In response to your request for more information at the December HDC meeting, I have put together a few pages about the proposed development at 413 E. Huron St. The first 5 pages are the comments sent to the Mayor, City Council and Planning Commission, Planning Staff, and the Design Review Board by the Downtown Design Guidelines Citizens Review Committee. The Citizens Review Committee is comprised of representatives from all of the near downtown neighborhoods that are adjacent to D1 and D2 zoning areas.

401-413 East Huron Street Proposal
Comments of the Downtown Design Guidelines Citizens Review Committee
3 January 2013

E. HURON STREET ELEVATION

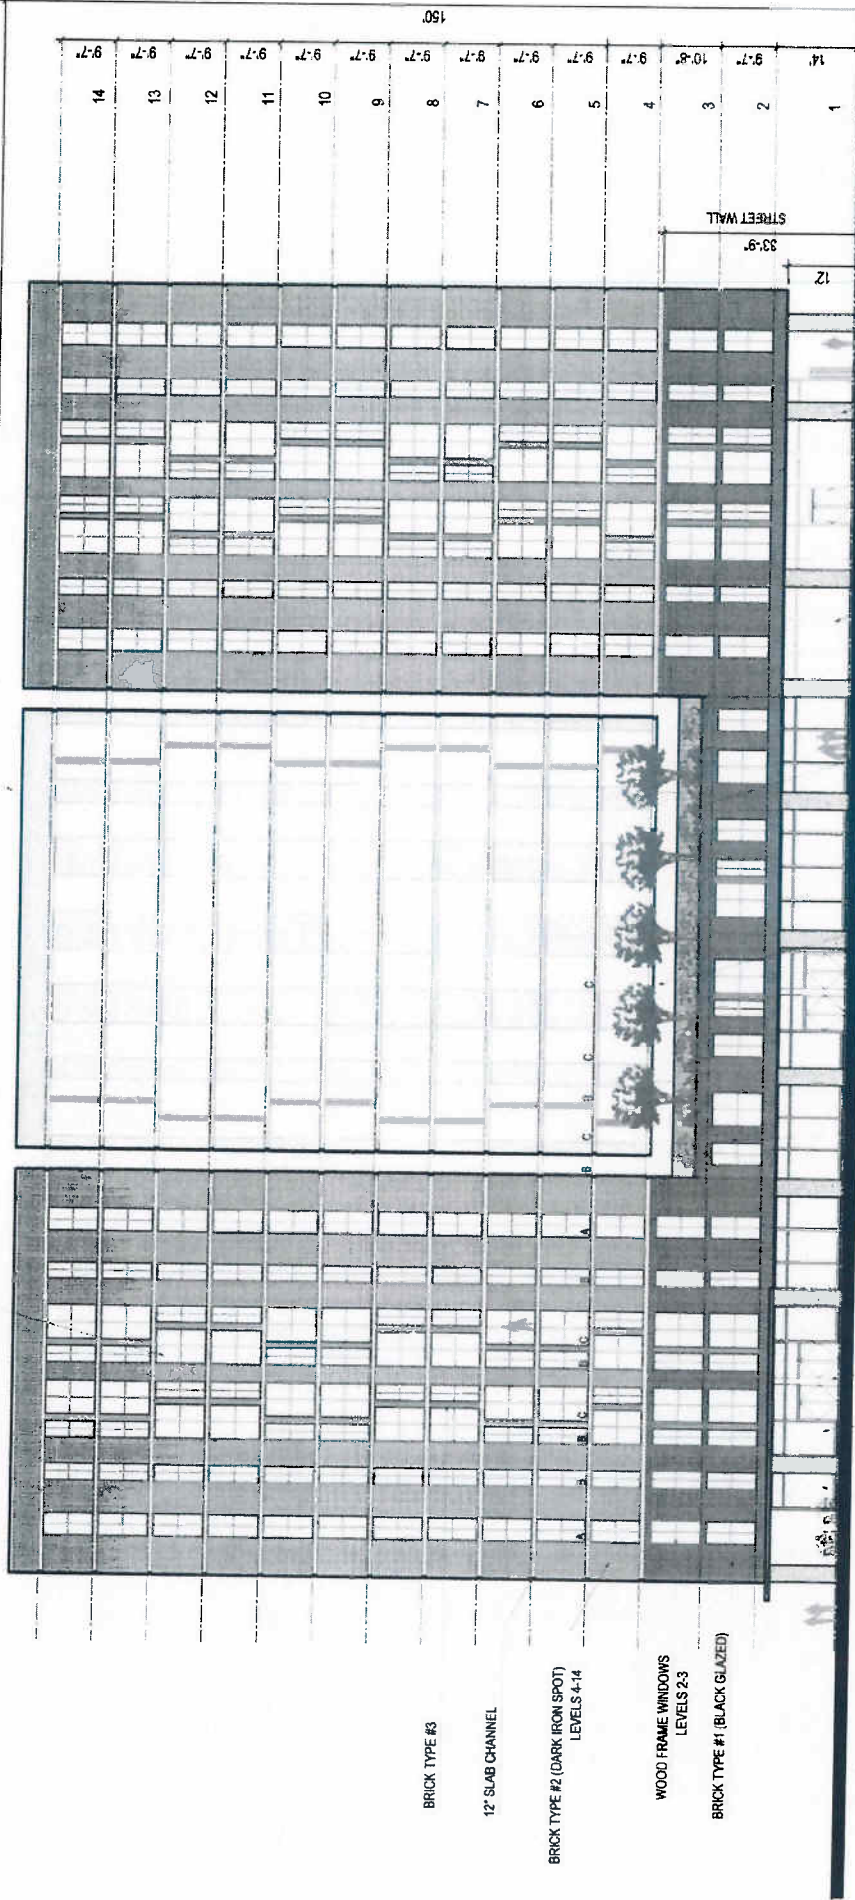
4. Without a setback of the building on Huron Street, the visual impact looking east because of a shift in the lane pattern of the street will actually result in an "outset" of the structure on the Huron Street frontage.

NORTH ELEVATION

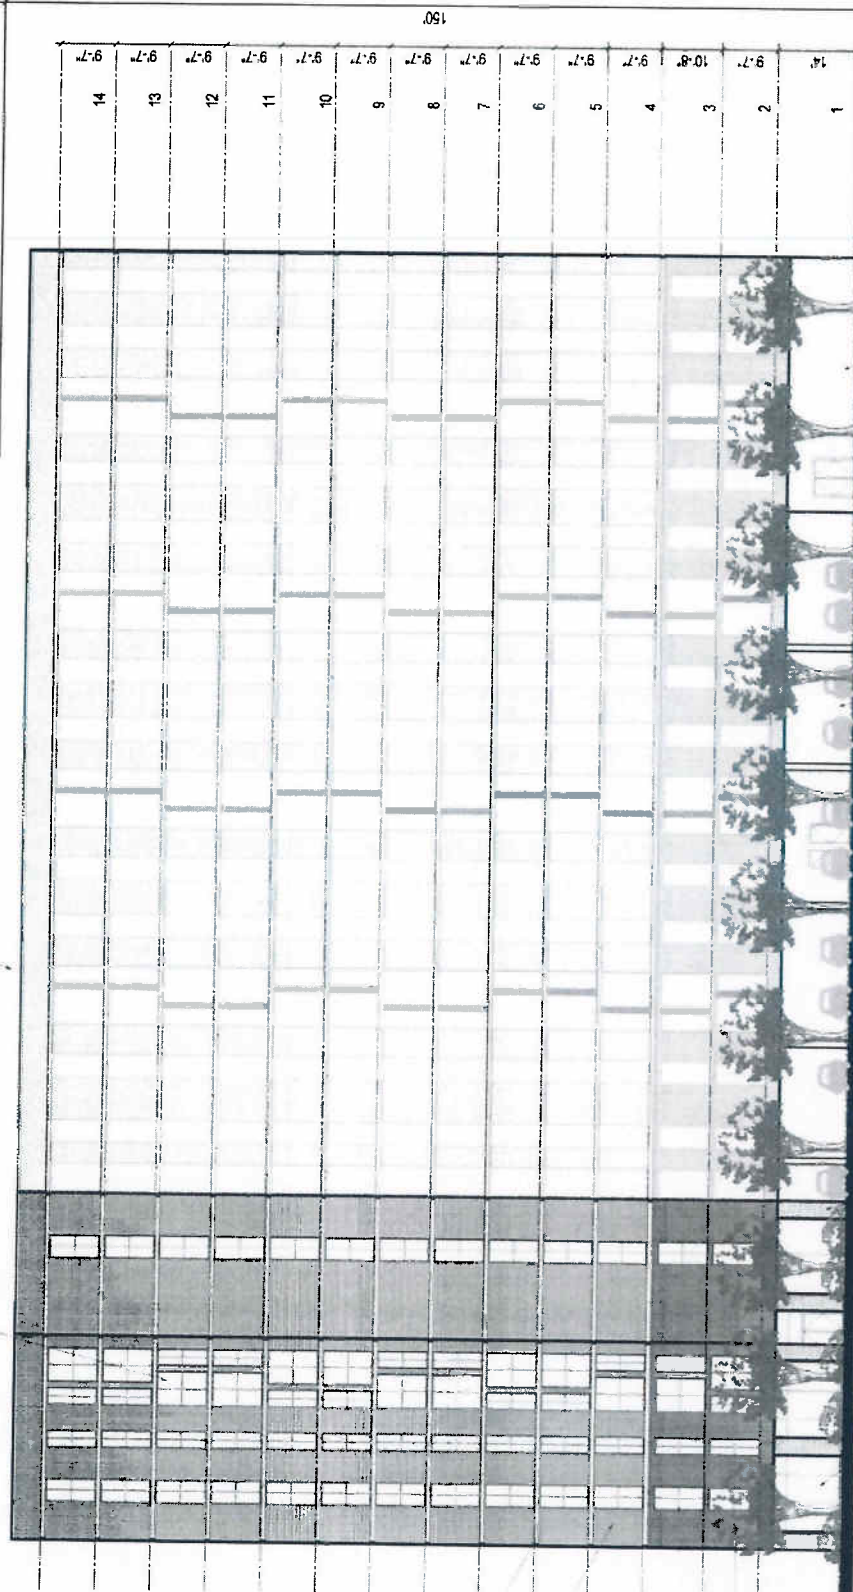
8. Noise pollution from mechanical equipment will impact adjacent and nearby residential properties.
9. On its north side, the project needs a solid masonry (brick) wall that is 100% opaque, and not the 80% opaque aluminum slatted fence currently shown. In addition, the wall should be a minimum of nine feet high. Both are needed to screen out incompatible noise and to protect the adjacent residential properties from unwanted trespass.
